Technical Review Comments on
October 2021 CCP update for MMD Permit No. SF002RE,
LAC Minerals (USA) LLC Cunningham Hill Mine
New Mexico Mining and Minerals Division Public Hearing
Santa Fe, NM November 2, 2022

James R. Kuipers P.E., Kuipers & Associates

Cunningham Hill Mine October 2021 CCP Update

Cunningham Hill Mine Reclamation Project

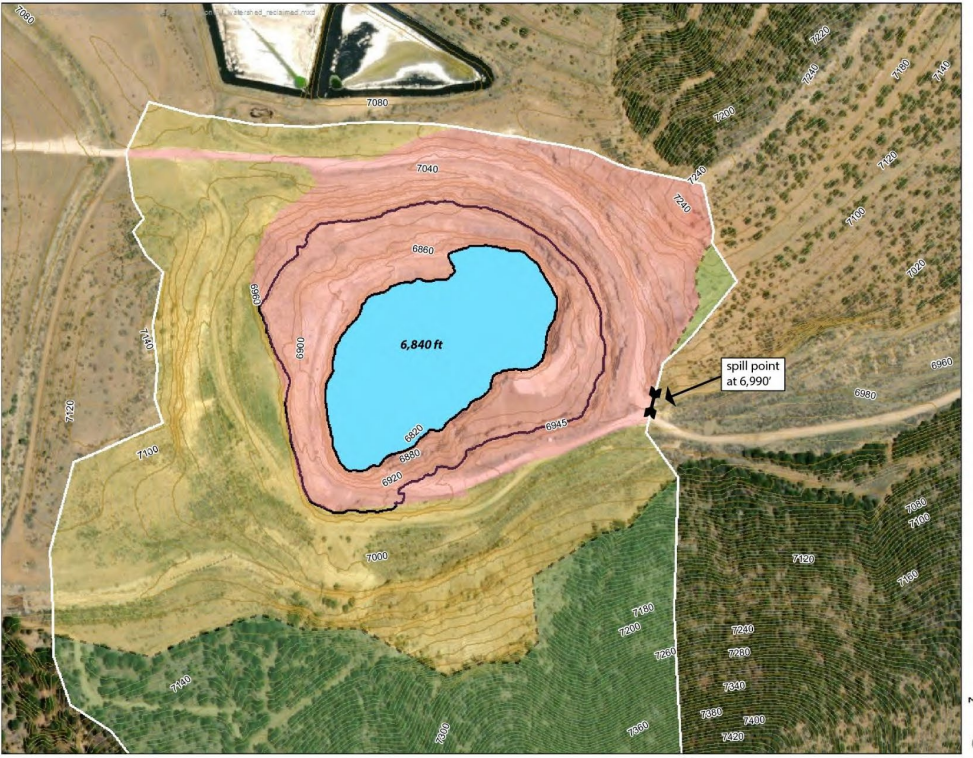
Watershed total area	70.51 acres
Undisturbed area	30.25 acres
Reclaimed area	20.89 acres
Un-reclaimed area	14.72 acres
open pit pool	4.65 acres

- Watershed total area
- Undisturbed area
- Reclaimed area
- Disturbed area, unreclaimed
- open pit water surface area (6,840 amsl)

Figure 7. Graph showing observed water levels at the Open Pit and nearby monitoring wells, from 1994 through 2019.

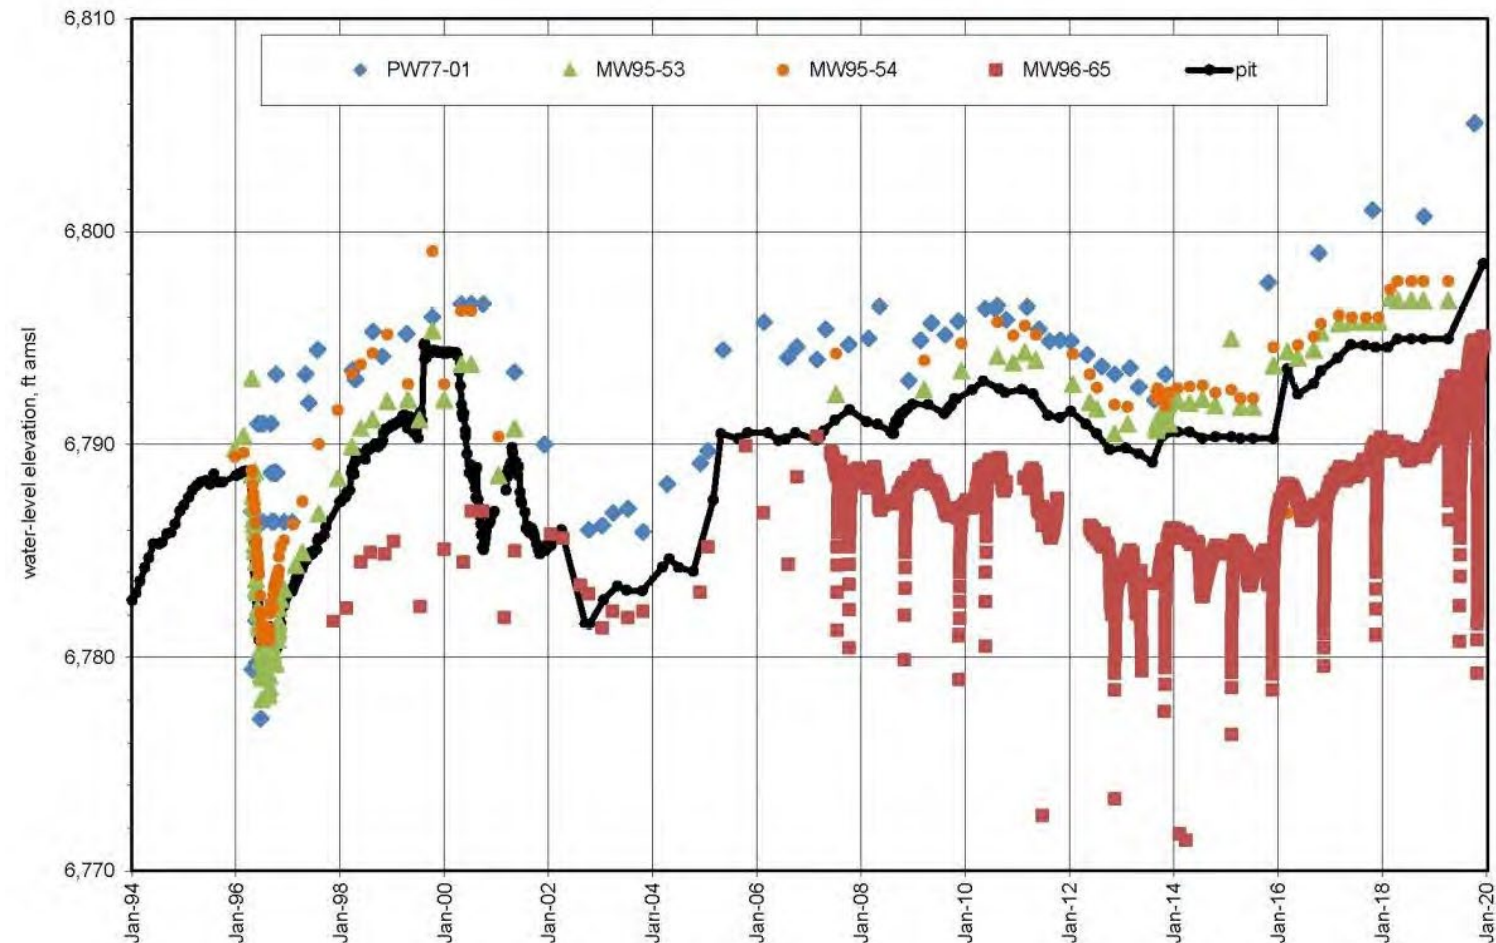
The expected steady-state Open Pit water levels is 6,800 with the potential for the pool level to rise to 6,840 ft amsl (Fig. 6). The observed rise in Open Pit water levels over the last 10 years has been at an average rate of 0.8 ft/yr (Fig. 7).

Station Climate Summary: 06-15-2022 to 09-30-2022 (Monsoon Season)

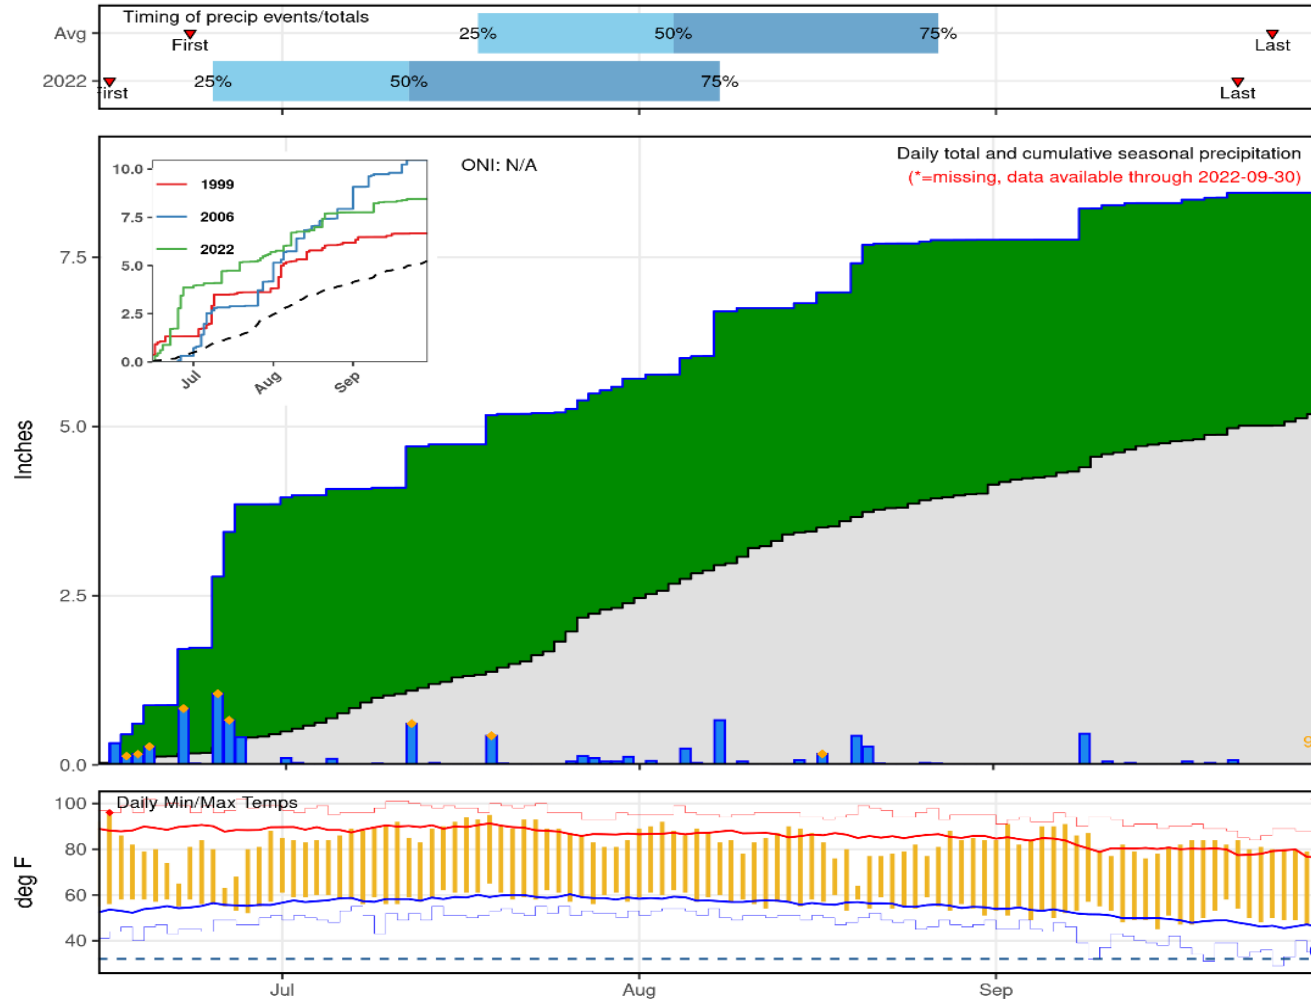
Climate – Climate Change
